From: Robert Story
Sent: 24/01/2024 2:41:15 PM
To: Council Northernbeaches Mailbox
Subject: TRIMMED DA 2023/1832 Submission against proposal
Attachments: 5 PORTIONS - 24-1-2024.docx; Drg-01 effect on 3 portions.pdf; Drg-02 View from Lovett Bay.jpg; Drg-03 tower look over 3 portions.pdf; Drg-04 profile of site.pdf; Drg-05 boundary error appendix 1.pdf; Drg-06 Location EMA part of LB4 pdf; Drg 07 Shadow line section pdf; Drg 08 estimated shadow.pdf;

OBJECTIONS AND COMMENTS ON DA 2023/1832

5 PORTIONS, LOVETT BAY NSW

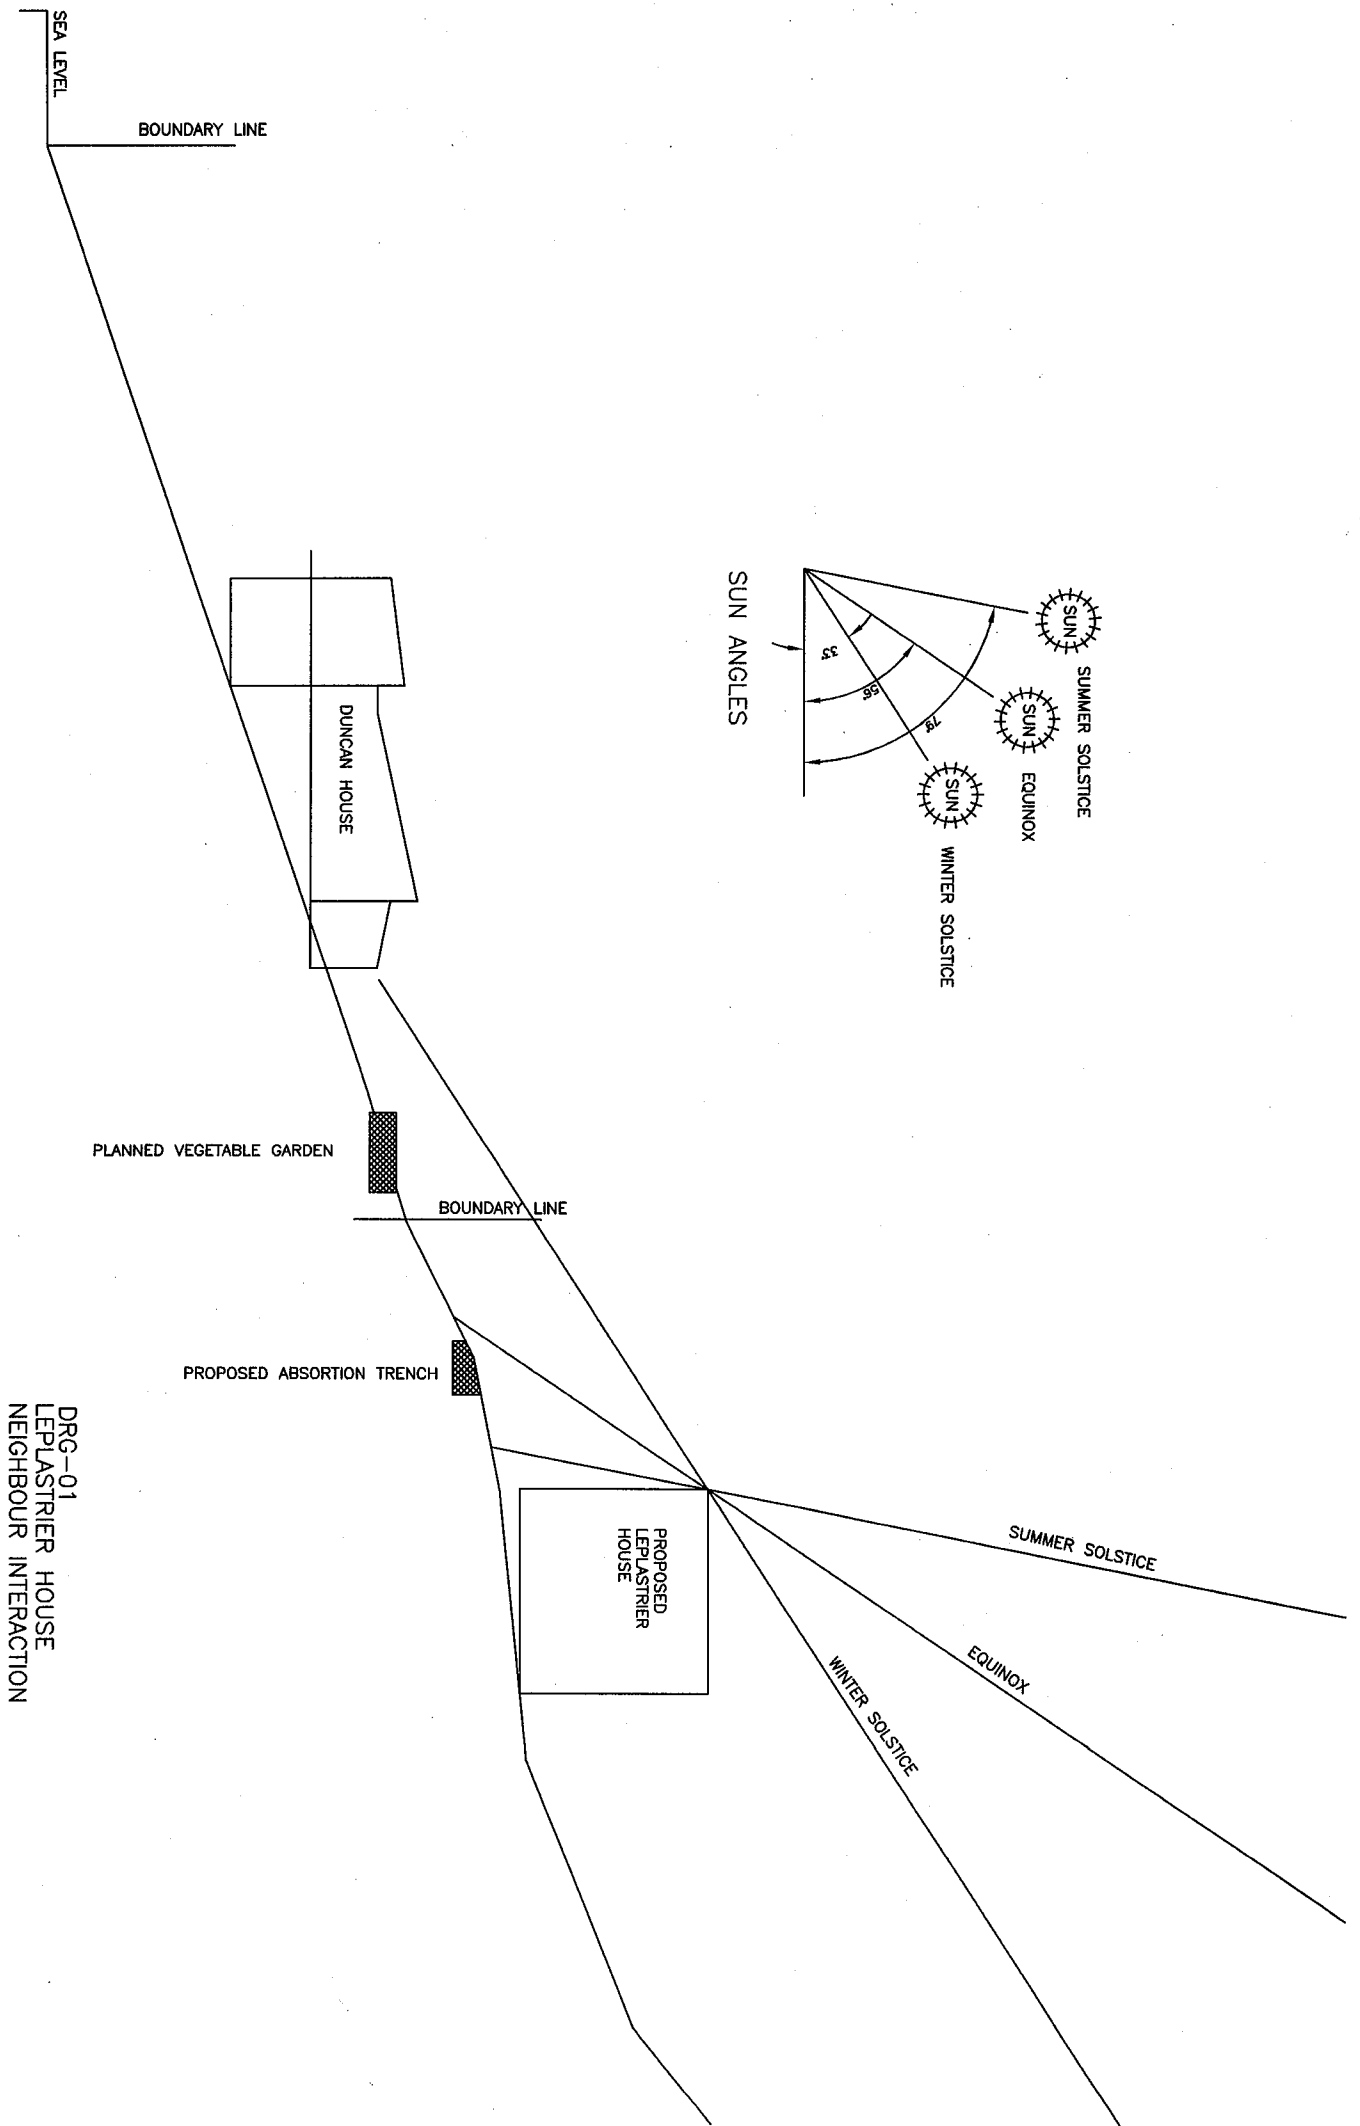
There is a fundamental error in the shadow lines provided. *See DRG 01, 07,08.*

Analysis does not take into account that the land between 5 Portions and 3 Portions, falls steeply away at around 20 degrees. The shadow lines chase the sloping land until the shadow line catches up. Shadow length is around 11 metres, whereas I have calculated a shadow of approximately 25 metres. **See DRG 07.**

We can argue the correct shadow length, but the simplest solution is to carry out a site measurement. A theodolite can be set up at the Duncan House to sight a measuring staff at the Leplastrier designed building at the front elevation. Knowing the distance and the angle, an accurate drawing can be compiled. **See DRG -07.** No surveyor is required as I have a theodolite and can do a full and accurate check with a representative of the Leplastrier family.

DRG-03
TOWER LOOK OVER DUNCAN
HOUSE

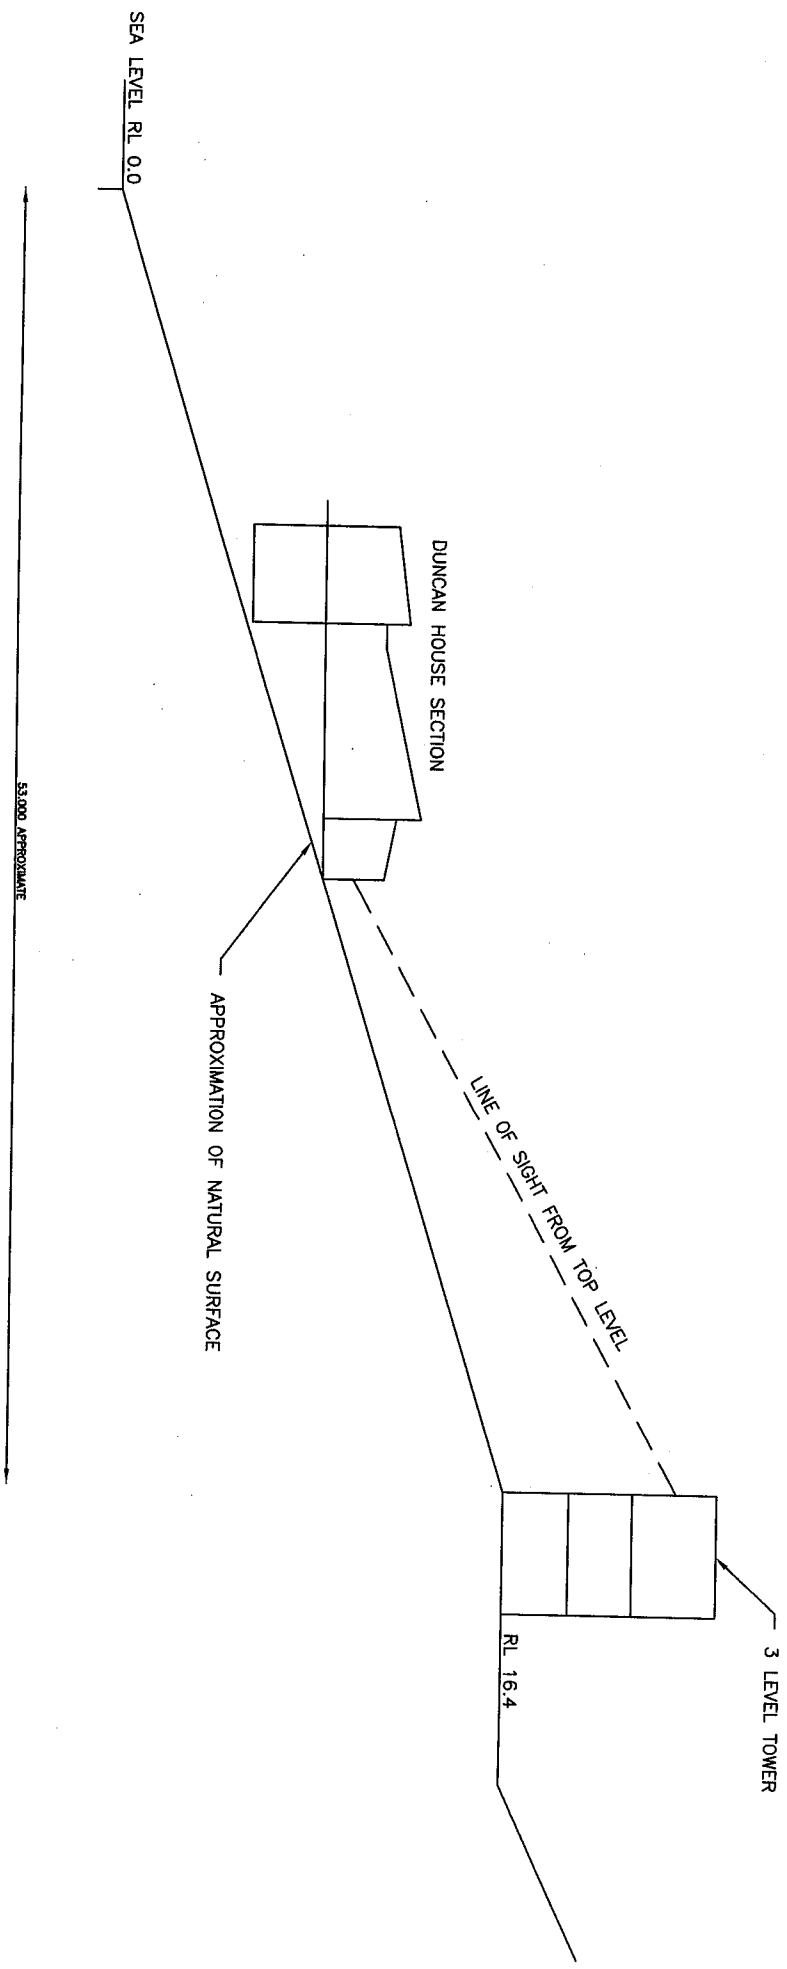
3. 5 Portions site is subject to high moisture content especially in heavy rains resulting in intermittent and semi-permanent springs.
4. Geotech report misrepresents the steepness of the site and the problems with water run-off.
5. Shadow lines are grossly understated and need to be reinvestigated. The shadow of the house would come to the back door of 3 Portions, which means that main building and the tower would dominate the view from that position.

Figure 3.1: Profile Cross-section south to north (site building envelope in blue)

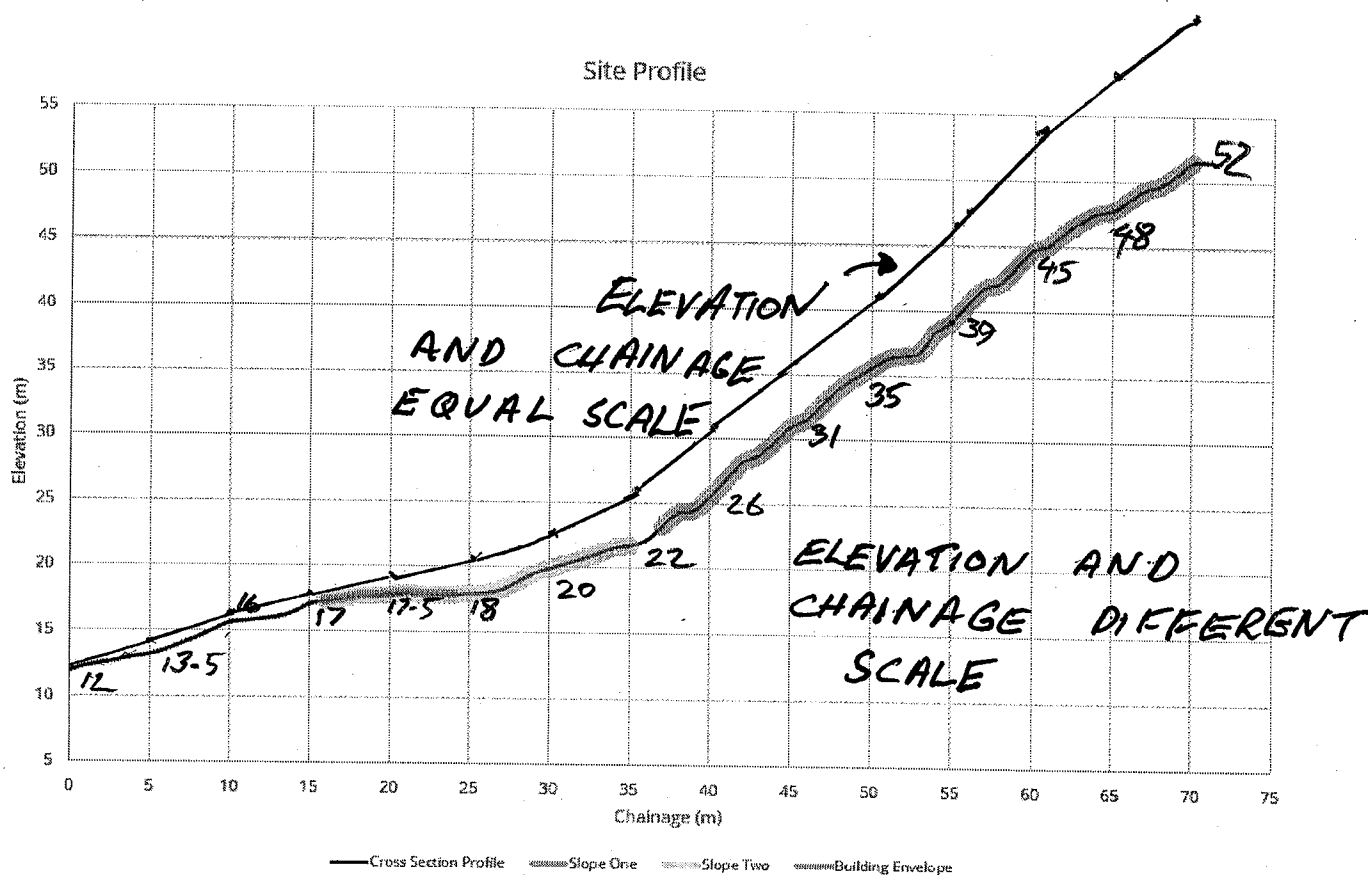
Figure 3.1 profile cross-section is misleading. The elevation and chainage are different scales, giving a shallower appearance of the slope of the land.

Refer to DRG-04 The block is steeply sloping from the water's edge, starting at 20 degrees and increasing to 45 degrees.

There are several horizontal benches or terraces cut into this slope but they do not affect the overall steepness of the block.

DRG-05 BOUNDARY ERROR
APPENDIX A

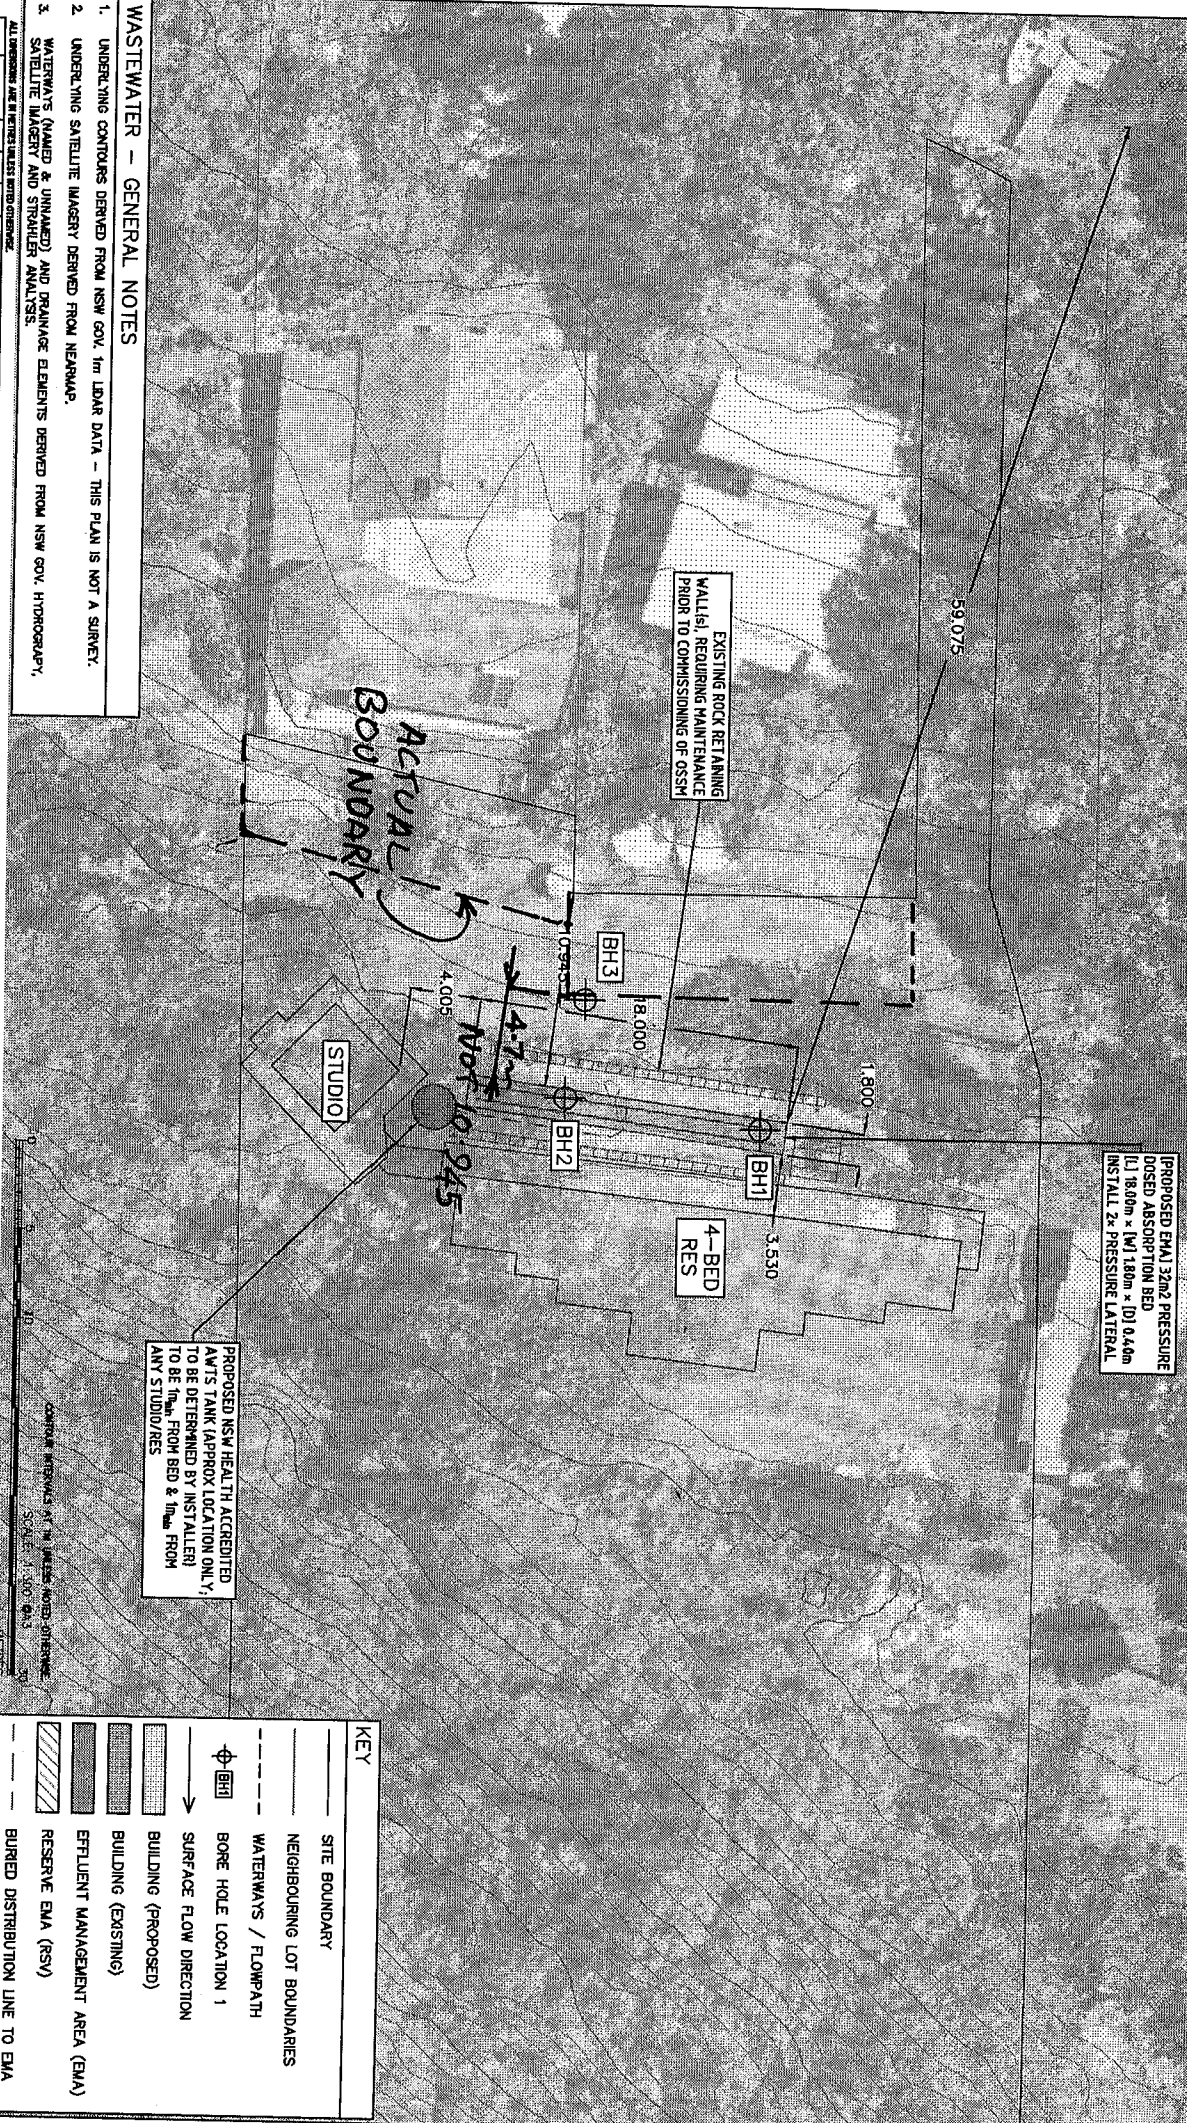
E Position of land application area in landscape: boundaries are incorrectly shown on Appendix 1 and are out by a distance of **7 meters**.

Appendix 1: Boundaries of Lot 3 and Lot 6 incorrectly drawn and show a major discrepancy of 7 meters. See drawings 5 & 6.

1. EMA is far too close to 3 Portions boundary and must be located at least 12 meters off this boundary.
2. Appendix 1 of the wastewater report shows the Portion 3 property boundary to be approximately 7 metres south of the actual location.
